BRIDGE: WEST PARAGON PARKWAY OVER LITTLE BLUE RIVER

Bridge Plans
General Plan & Elevation

3rd Party Review by HDR

DETAILS OF AESTHETIC STEEL GIRDER & ANCHORS AT END BENT & INT. BENT

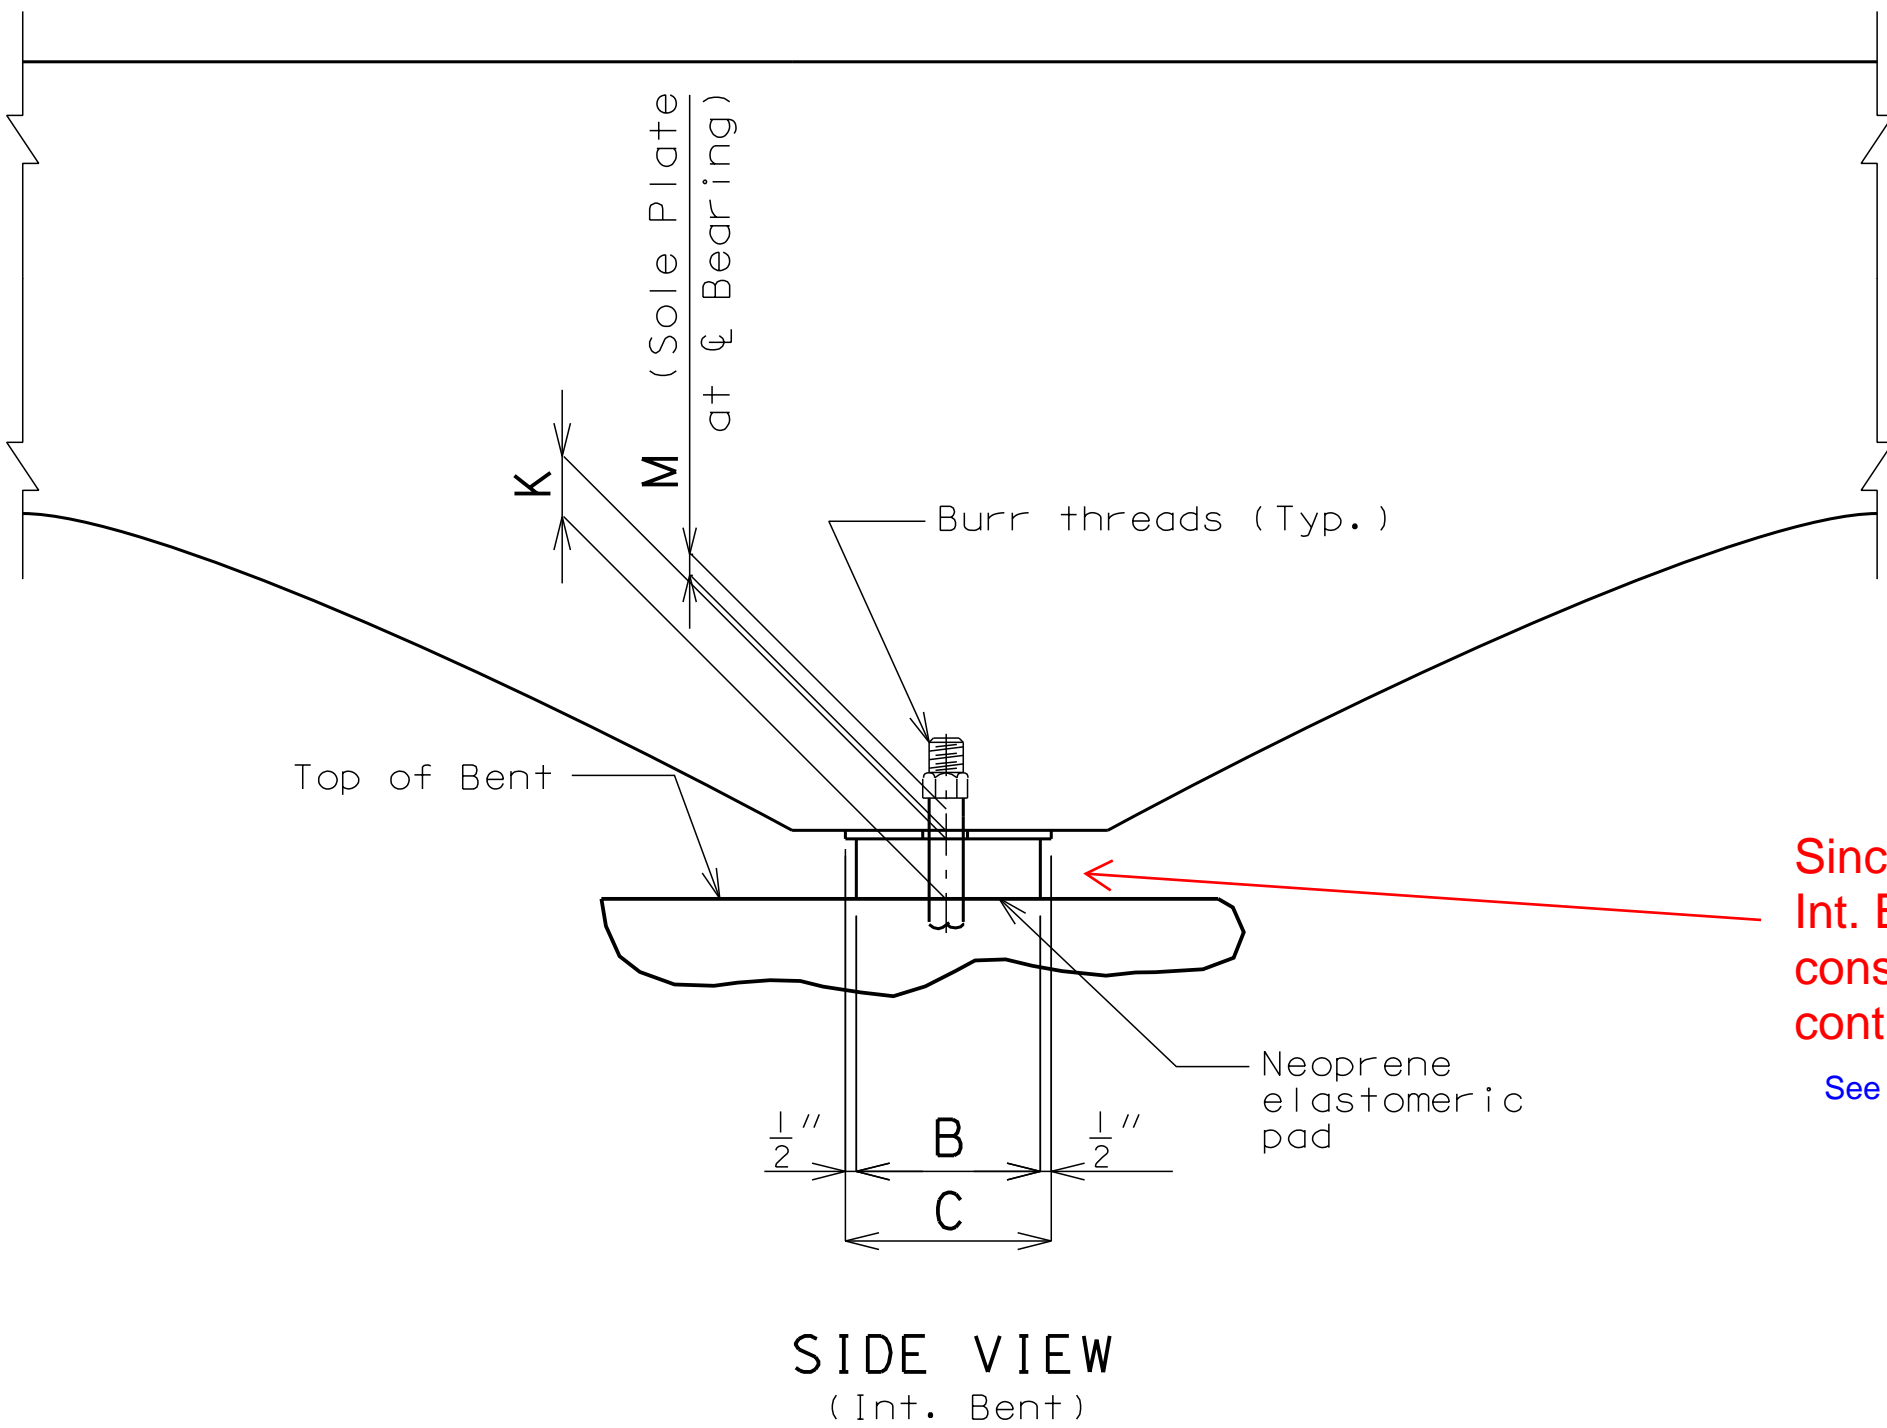
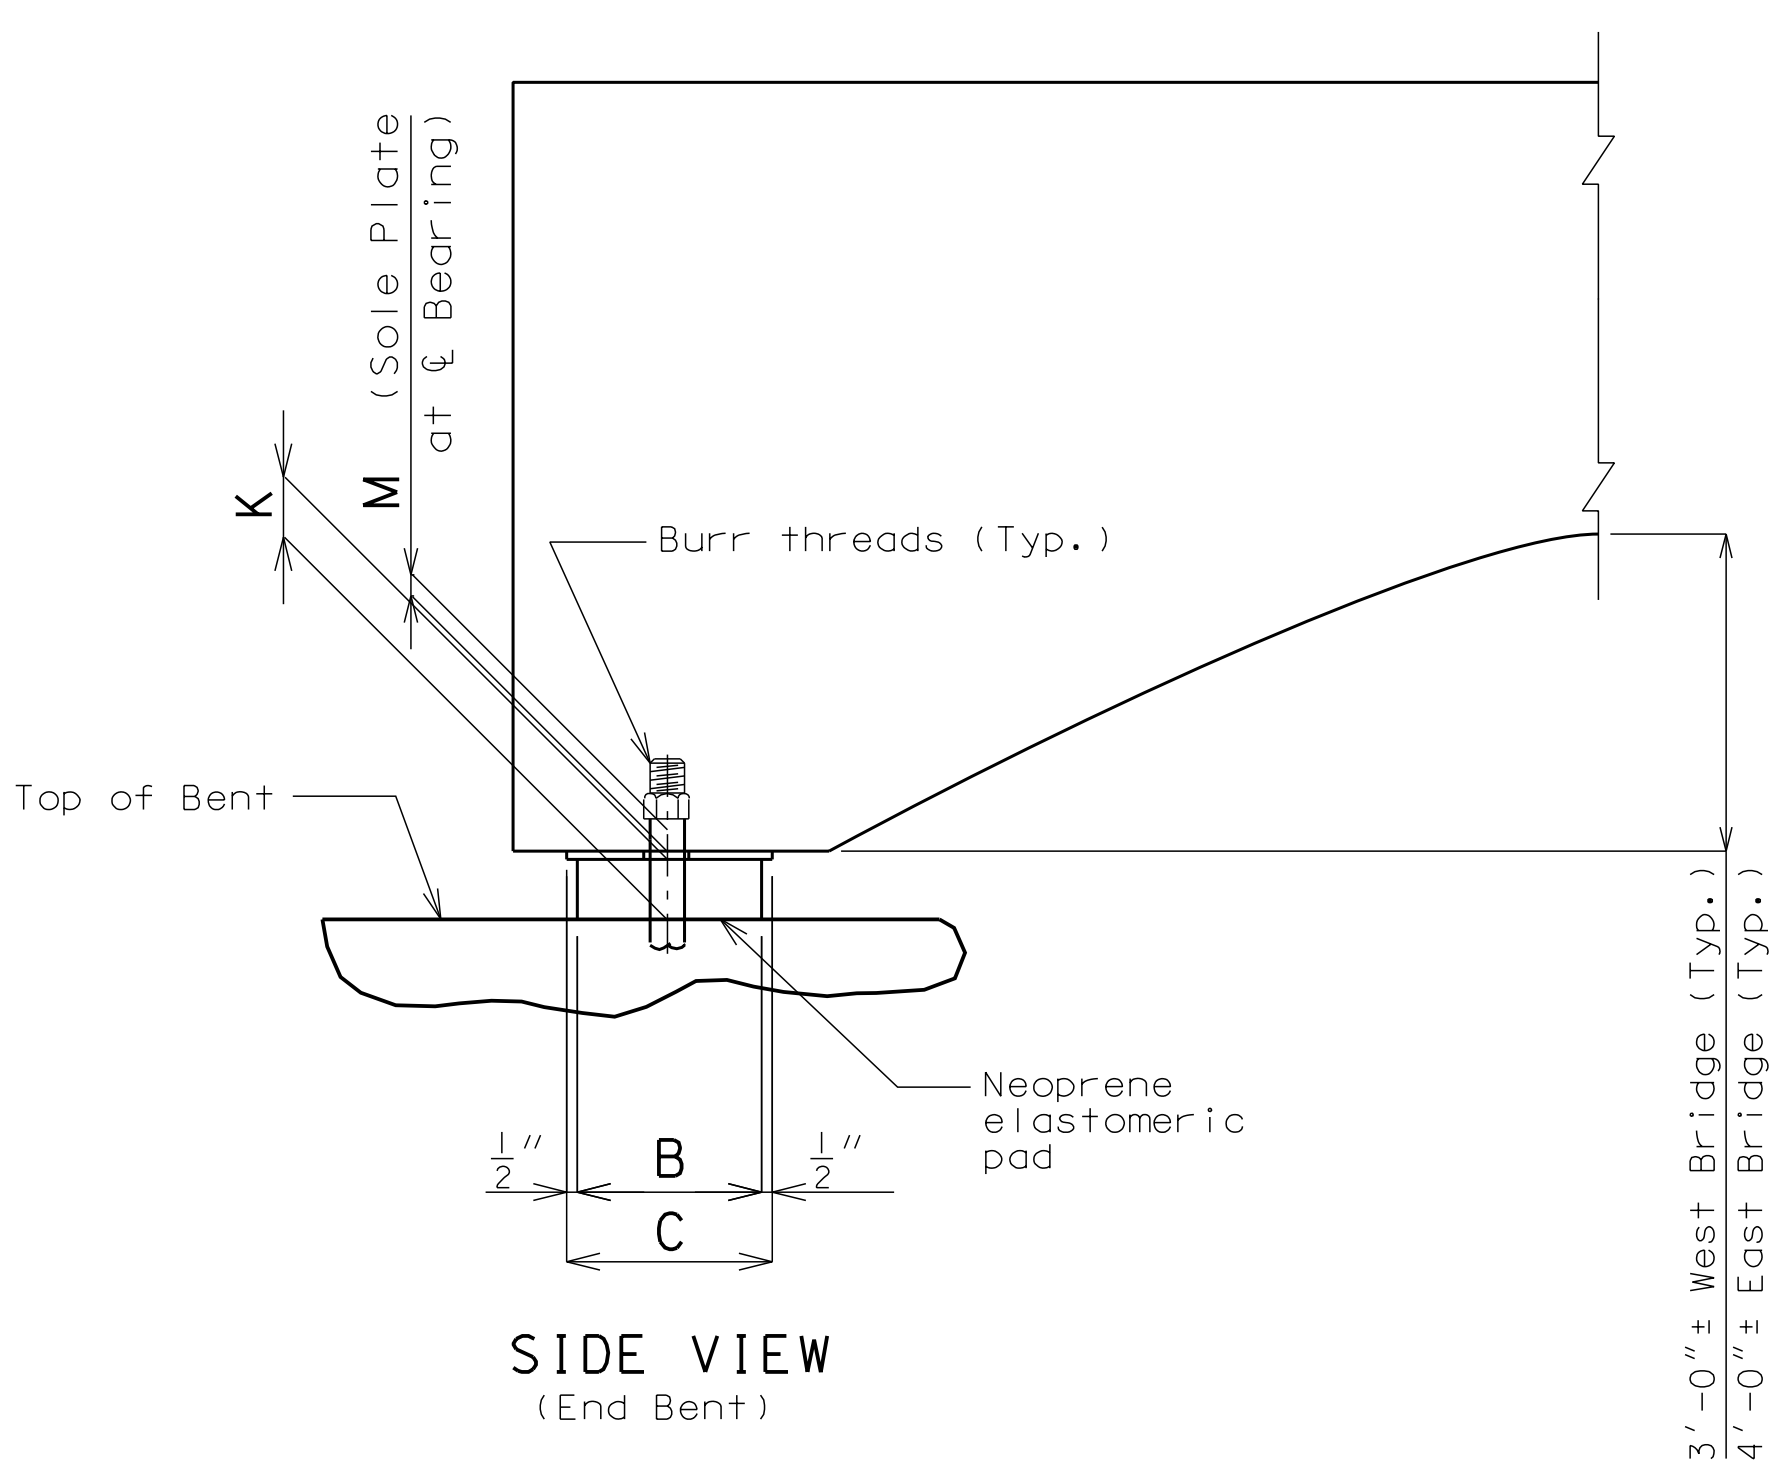
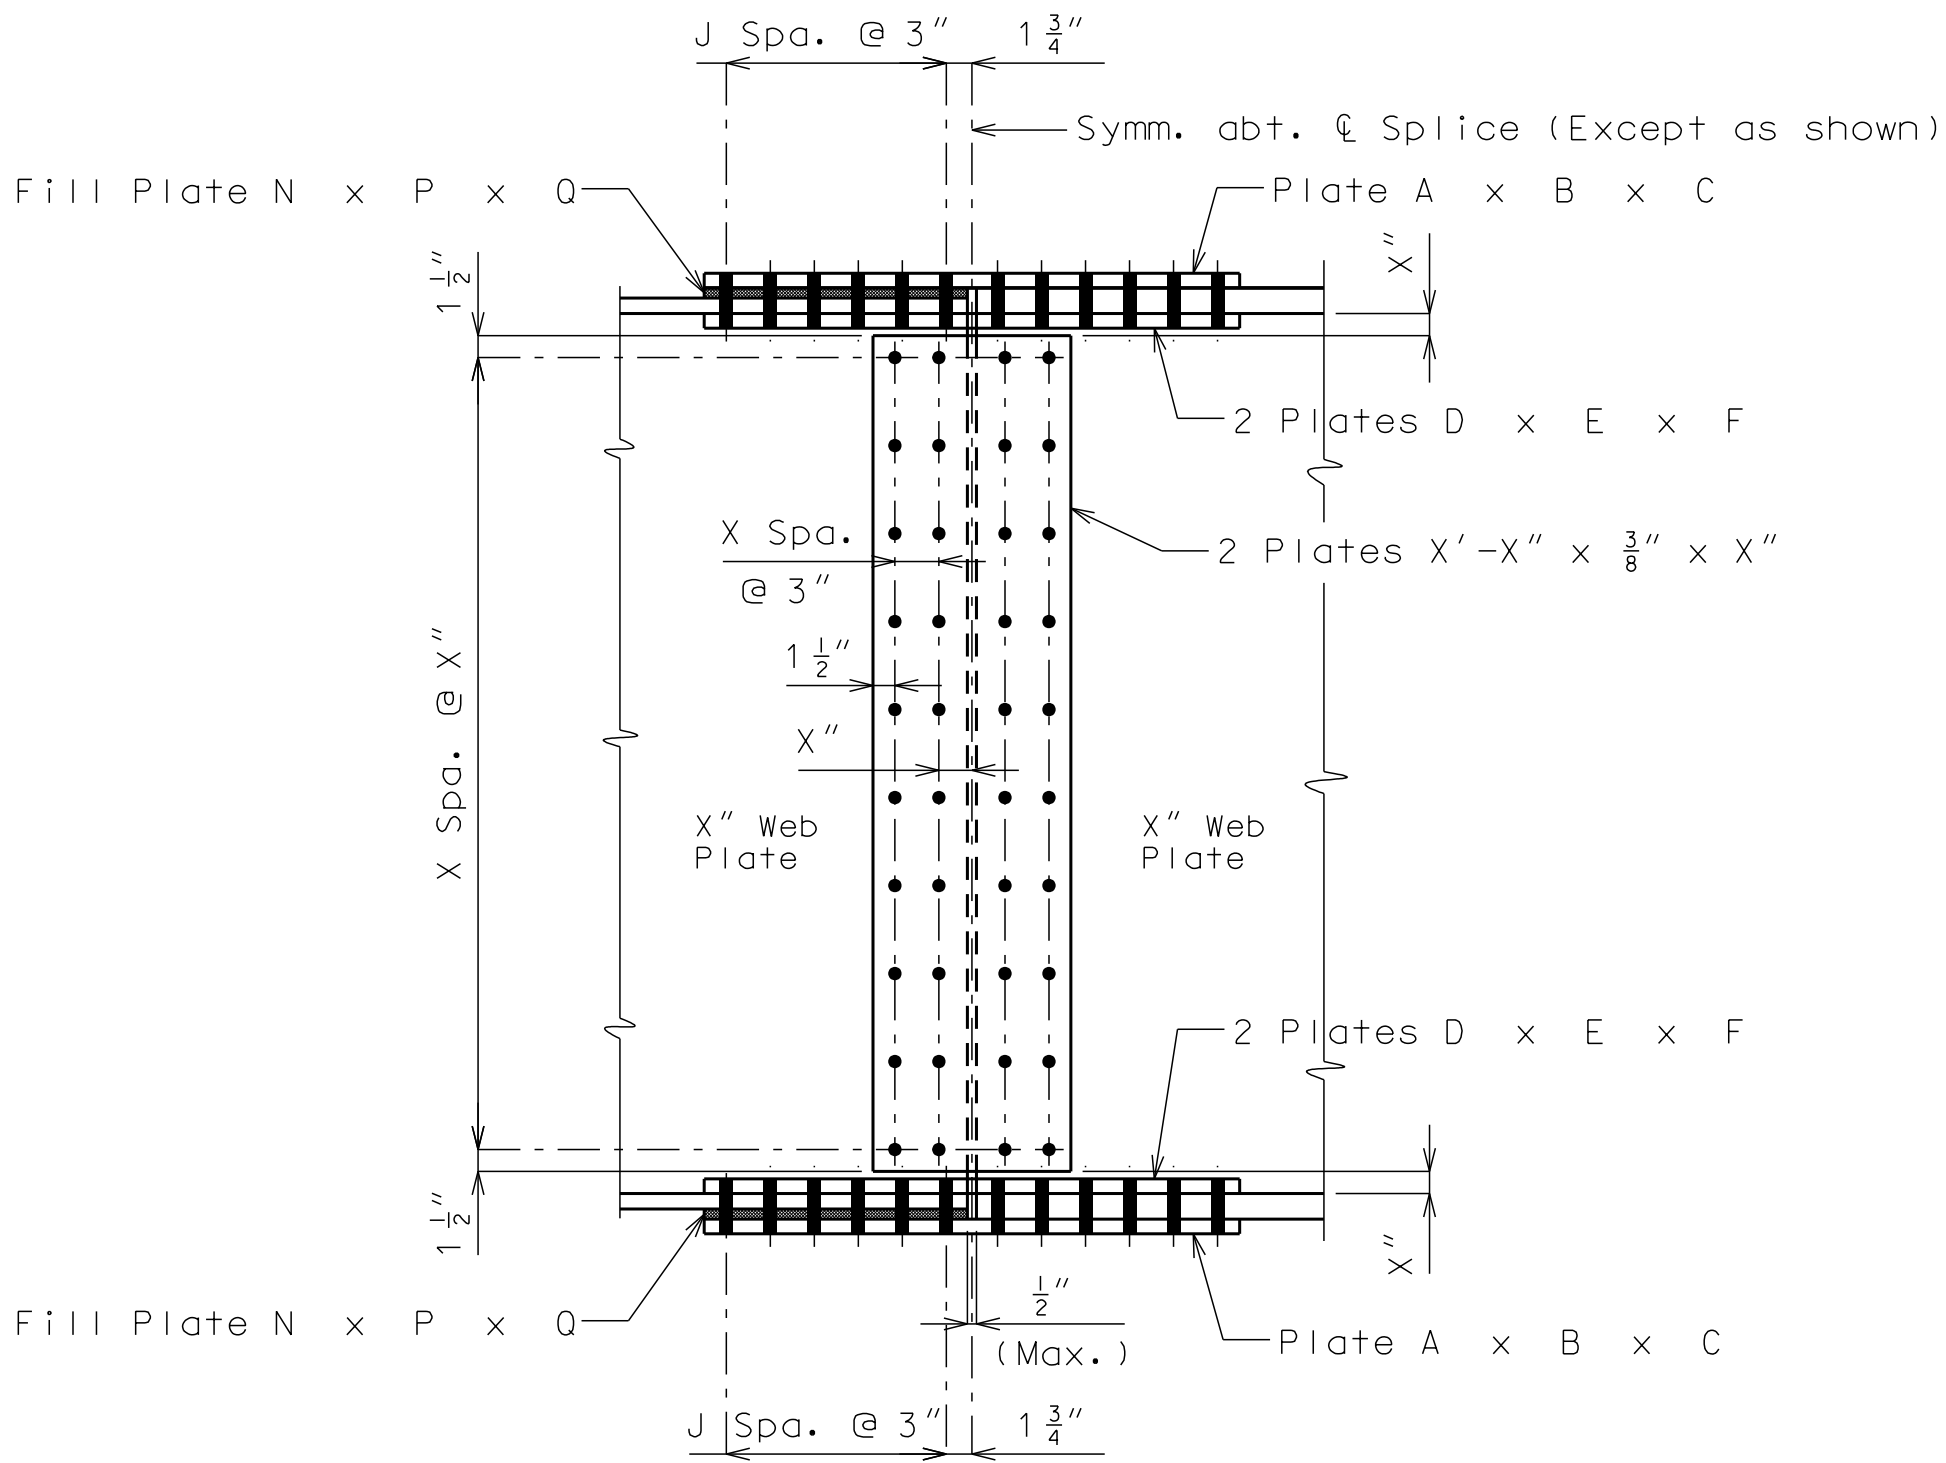
Since we are using such "stout" wall piers for Int. Bents, are expansion bearings being considered here to allow for expansion and contraction of superstructure?

[See previous response](#)
